Development Variance Permit Presentation – 884 Lampson Street

Purpose and Content of the Variance application

Floor Plan: Parkade P2 – Before & After

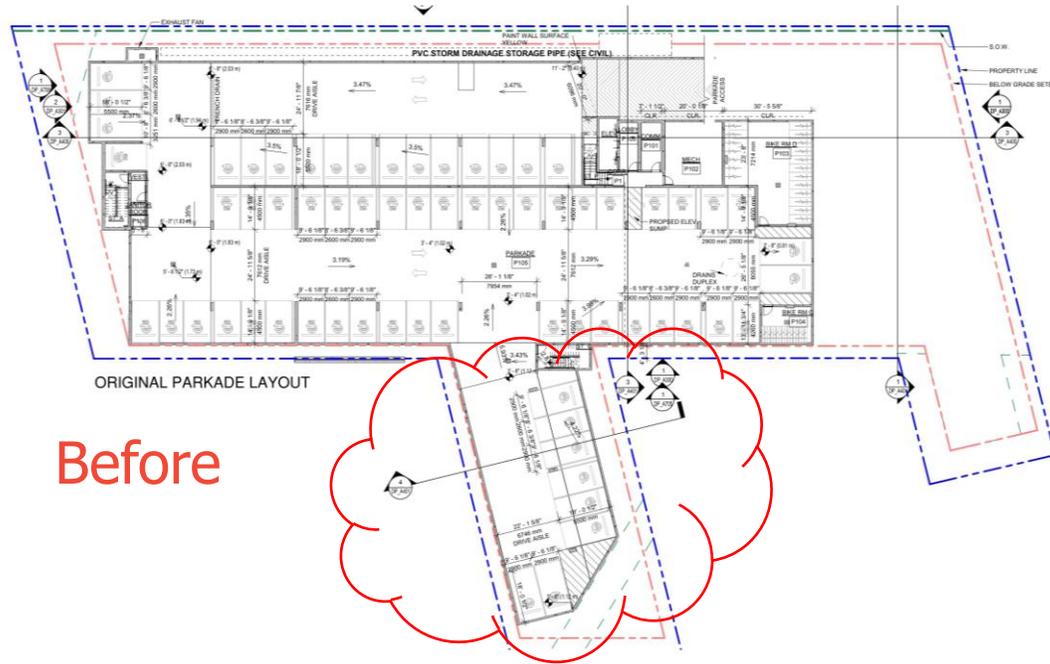
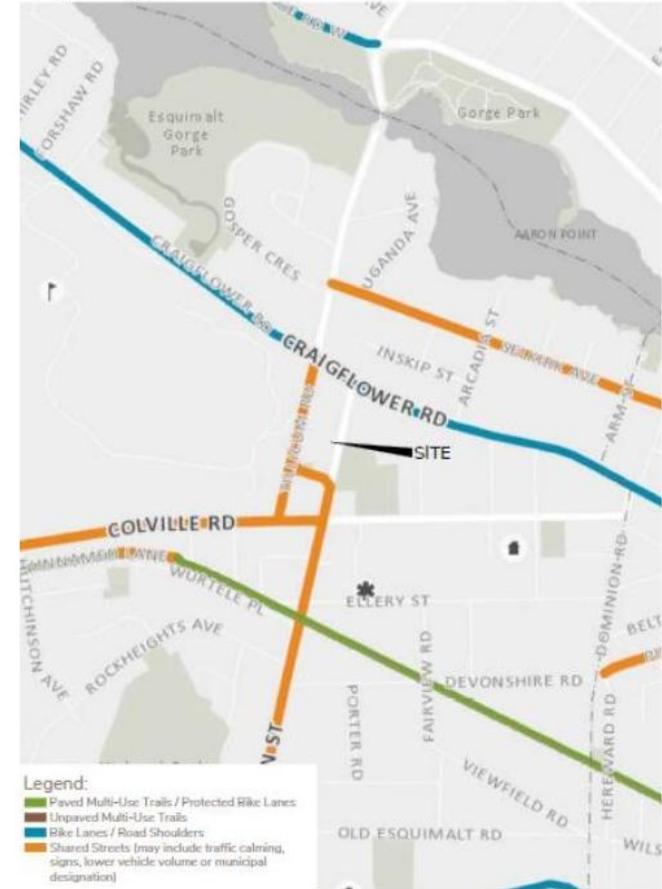
- Original zoning (late 2023) included a parking rate based on the Parking Bylaw of the time
- New Parking Bylaw was adopted in the summer of 2025 which reduced the requirements
- Proposed changes consistent with the bylaw as follows;
 - The new base rate is 95 stalls
 - The provision of one MODO car permits a 5% TDM reduction
 - Increase from 10% to 20% of all required long term bike parking spaces are designed for Oversize Bikes which would permit a 5% TDM reduction
 - New rate is 75 stalls plus 12 visitor stalls for a total of 87 stalls plus 1 MODO stall
 - Reduced parking rate from 0.92 to 0.73 with TDM
- No other changes are proposed
